Request for Information – Local Government Official Information and Meetings Act (LGOIMA) 1987

We refer to your official information request dated 5 August 2025, for information about building consent BC210296 and any assessment carried out under section 115 of the Building Act 2004. Specifically, you requested:

In November 2021 the Council issued building consent BC210296. The building consent related to the conversion of an existing commercial building into residential and retail units at the above address.

BC No: BC210296

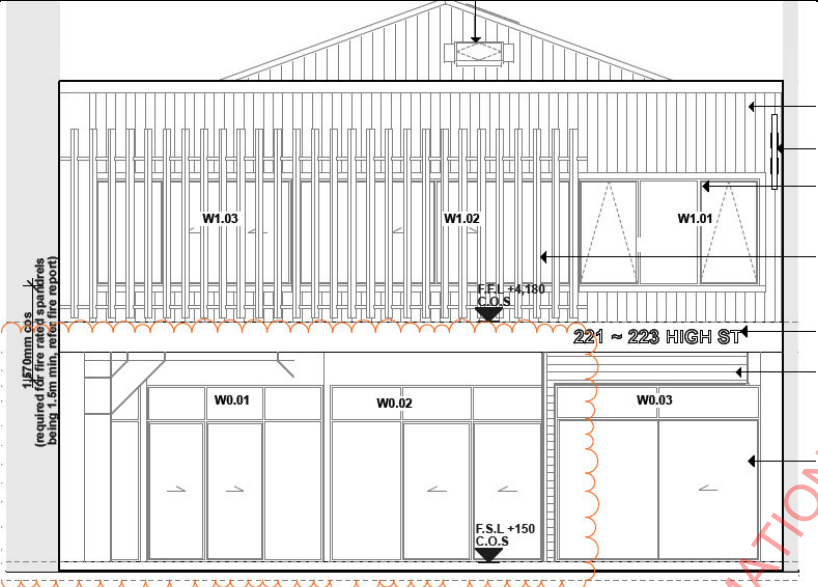
- Please dimension the height of the barrier above FFL. Please provide construction details and show fastening details to the building, and label materials to be used. Please demonstrate how these barriers comply with F4 as the gaps in horizontal members appears to allow for climbing.
- If a proprietary system please provide product information (including installation details) and include a PS1(issued within 12 months) from the manufacturer.

Based on the Southern elevation (see below) sliding windows to apartments 5 and 6 open more than 100mm and protection from falling is provided by aluminium louvres. Is this correct? Please demonstrate how these louvres provide an F4 compliant barrier in particular show a Dia100mm sphere would be unable to be dropped from these open windows. Check this one as the veranda is there if you fell.

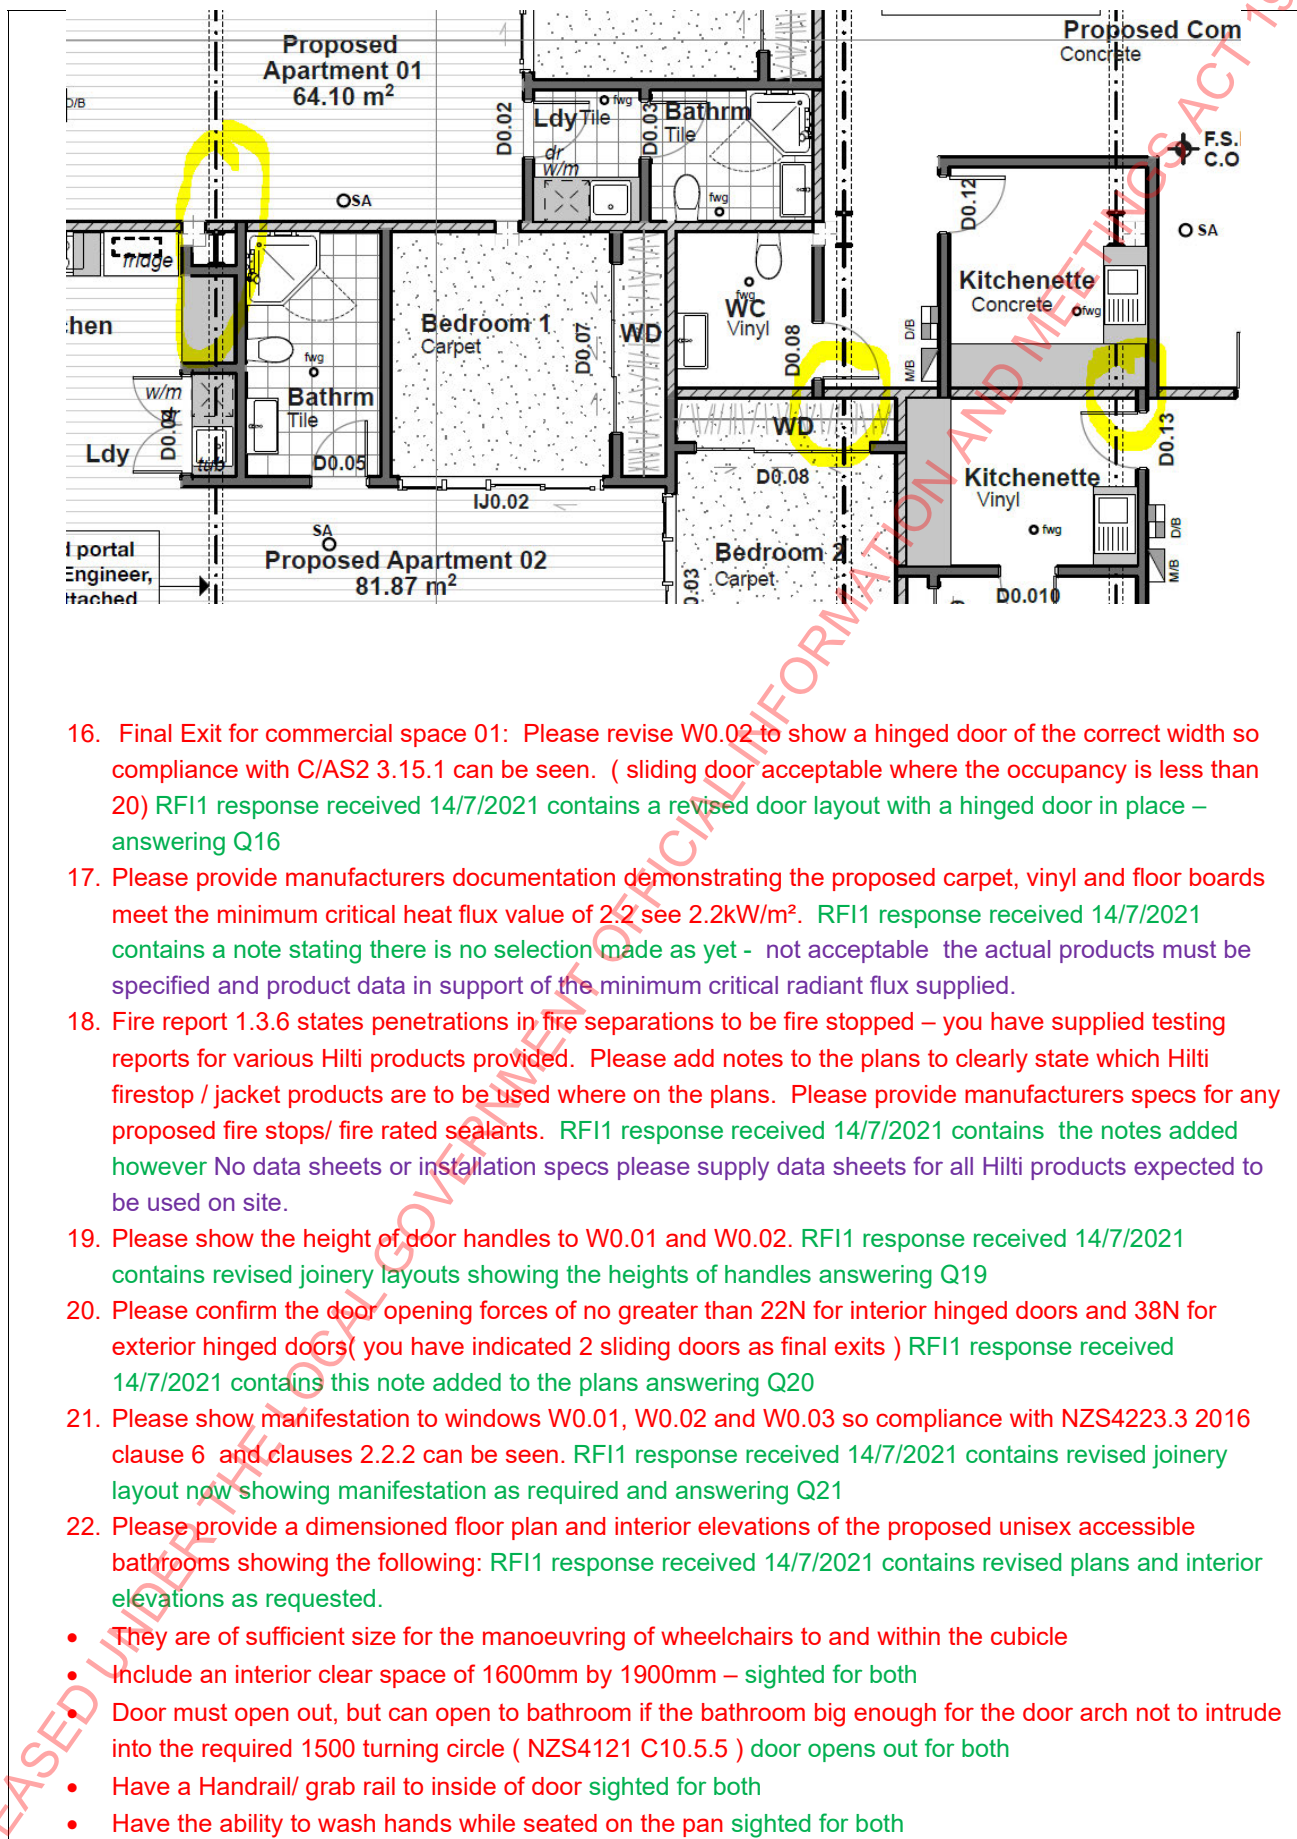
We can confirm that the ground floor portal frames don't need to be fully fire rated. The main gravity supports are still the existing concrete beams and columns. If the portal frames were damaged by fire, it will not cause any stability issue.

15. Please provide details showing steelwork penetrations through fire separations in particular how the integrity of the fire separation is to be maintained. (see below) RF11 response received 14/7/2021 contains a note stating that HILTI 606 fire stopping sealant to be used where steel penetrates the GIB FR walls – need to see data sheet for the HILTI 606 sealant. Does the ceiling to apartments 1 and 2 means that the beam penetration through the walls is within this protected area? is the purpose of the GIB 45min ceiling to mean the beam penetrations through the walls above this ceiling do not need to be fire rated?

CLEARSPAN SLAT PANEL ASSEMBLY - HORIZONTAL SLAT INFILL

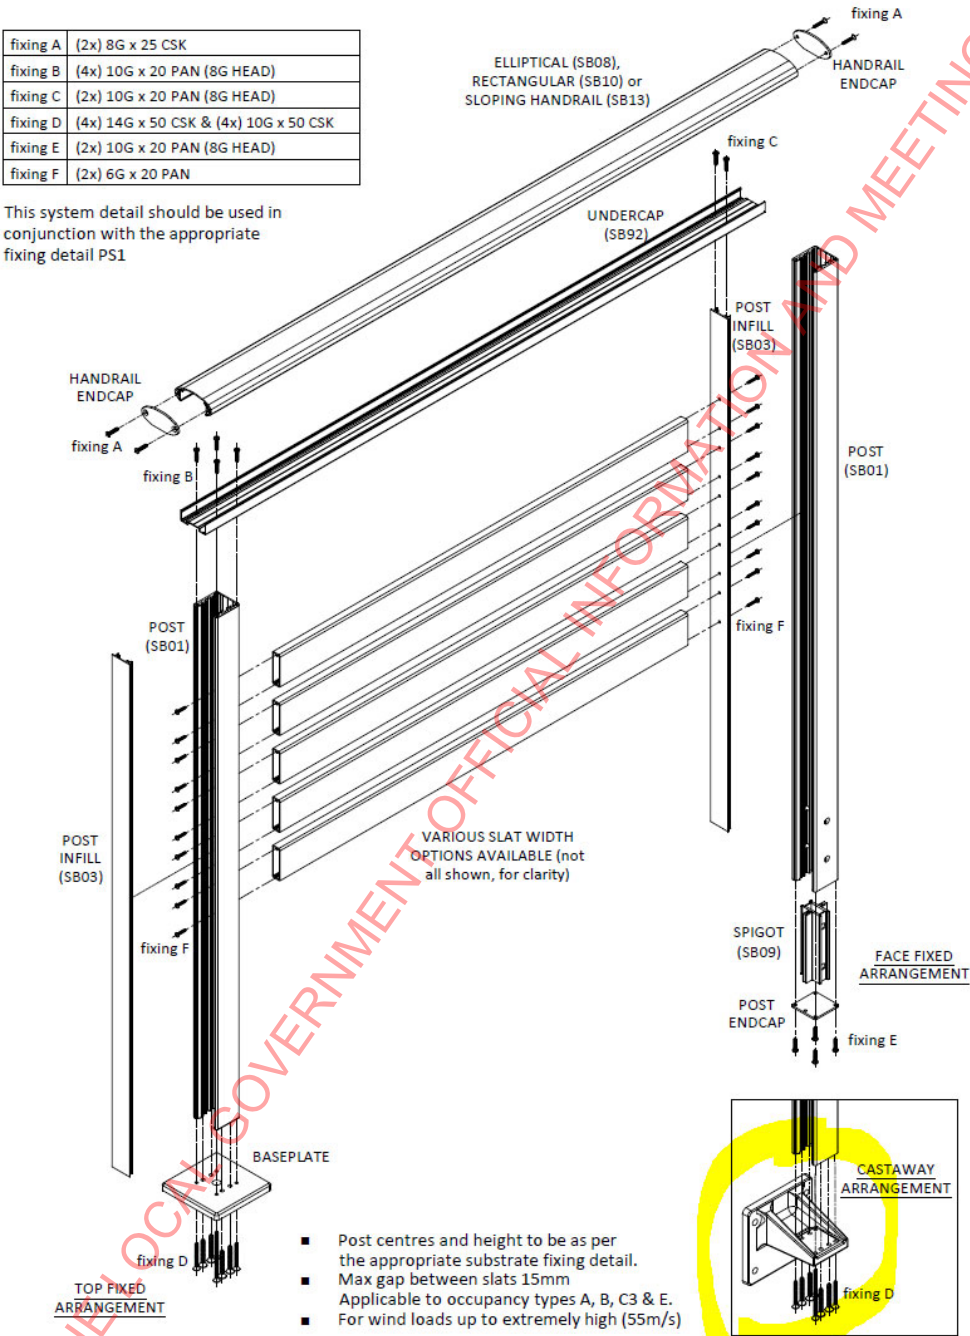
and sheet BL.2.1.9 does not specify this fixing.

Apartment 1: This apartment has just 1 external wall with windows.

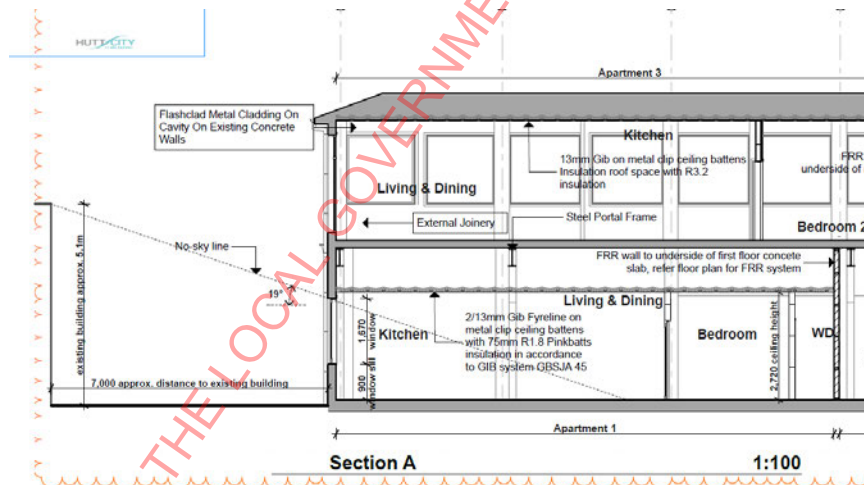
55. Please demonstrate (by providing a cross section showing window heights) how the bedroom (habitable space) complies with the requirement for visual awareness of the outside environment. RFI 1 response received 14/7/2021 contains a cross section showing the room see below I cannot see how G7 is met for this bedroom.

CLEARSPAN SLAT PANEL ASSEMBLY - HORIZONTAL SLAT INFILL

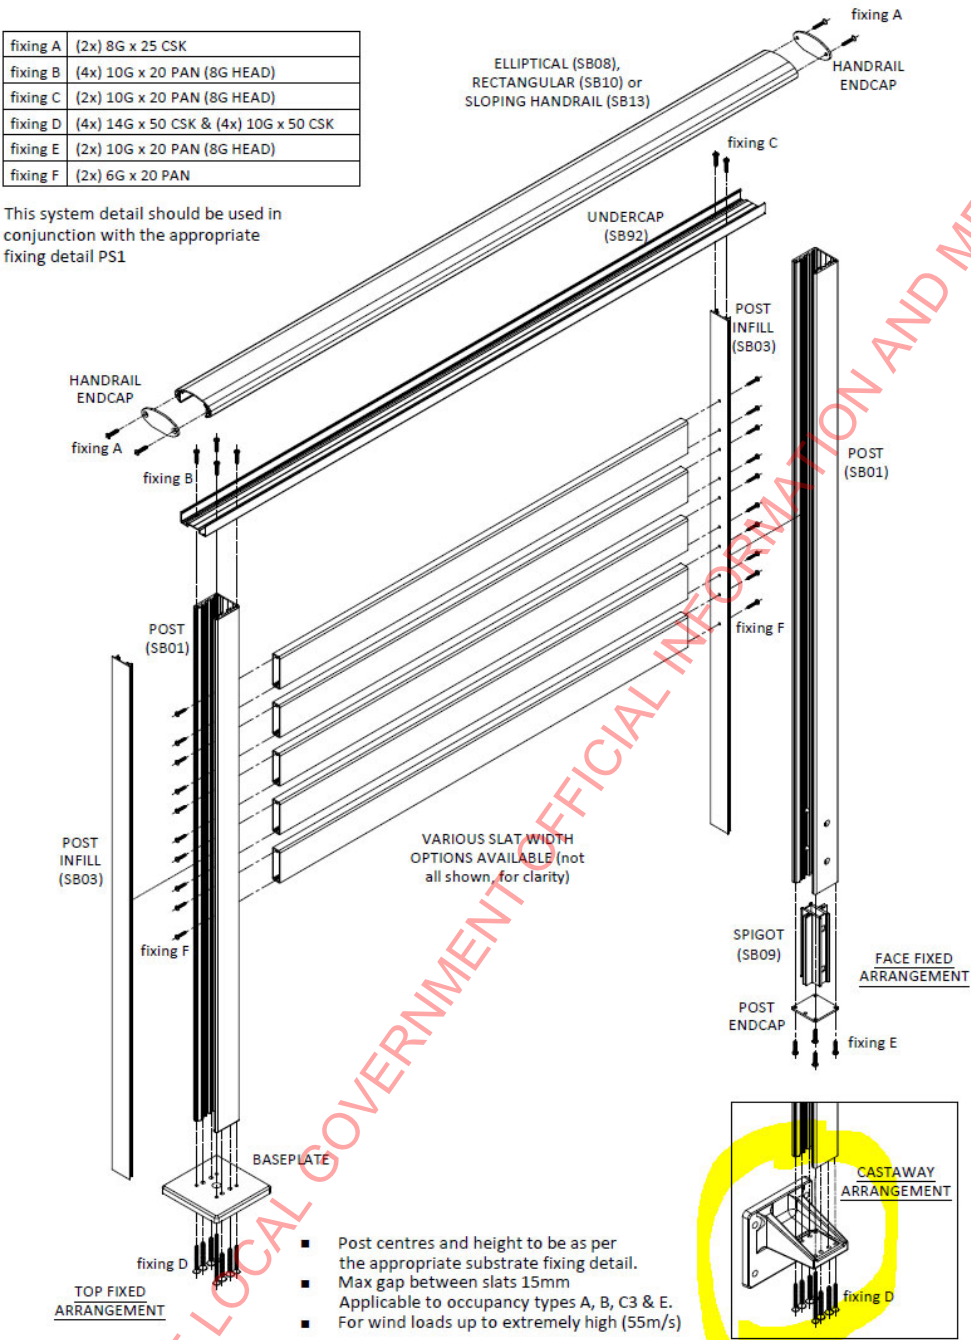
Further Question: Please provide fixing details for the Clearspan infill and the exterior wall. The PS1 supplied and sheet BL.2.1.9 does not specify this fixing. RF11 response received 23/9/2021 contains a fixing detail and (generic) PS1 to cover this detail for the fixing of the cast away bracket. The generic PS1's supplied for the entrance canopy and the horizontal slat system state they are valid for a BC issued 2 years after date on the PS1's which are 2020 so acceptable however the PS1 for the castaway bracket is dated 16/8/2019 and should be updated.

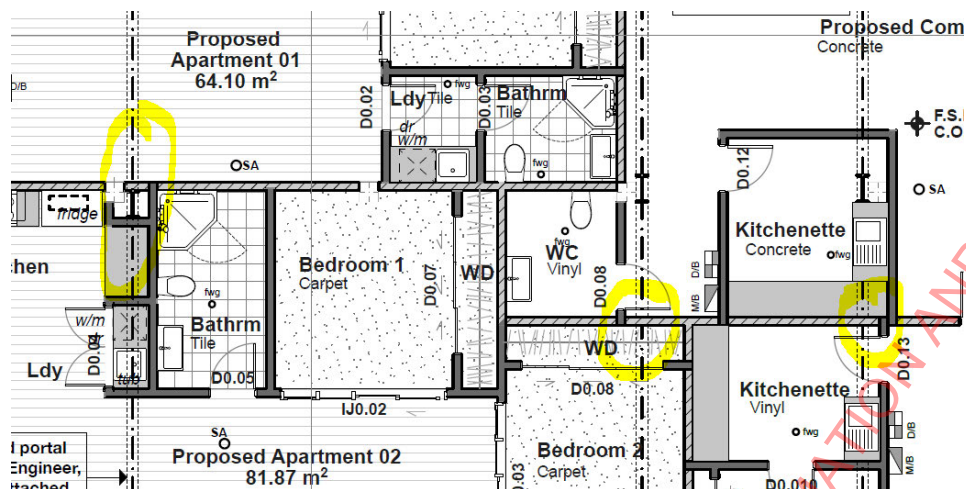
15. Please provide details showing steelwork penetrations through fire separations in particular how the integrity of the fire separation is to be maintained. (see below)

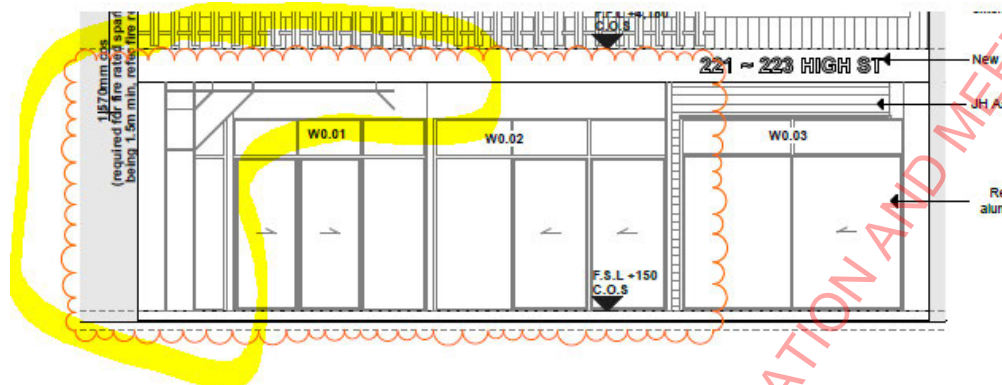
34. Please have the SED engineer provide a paint specification for the finish to the exposed section of portal frame. (see below)
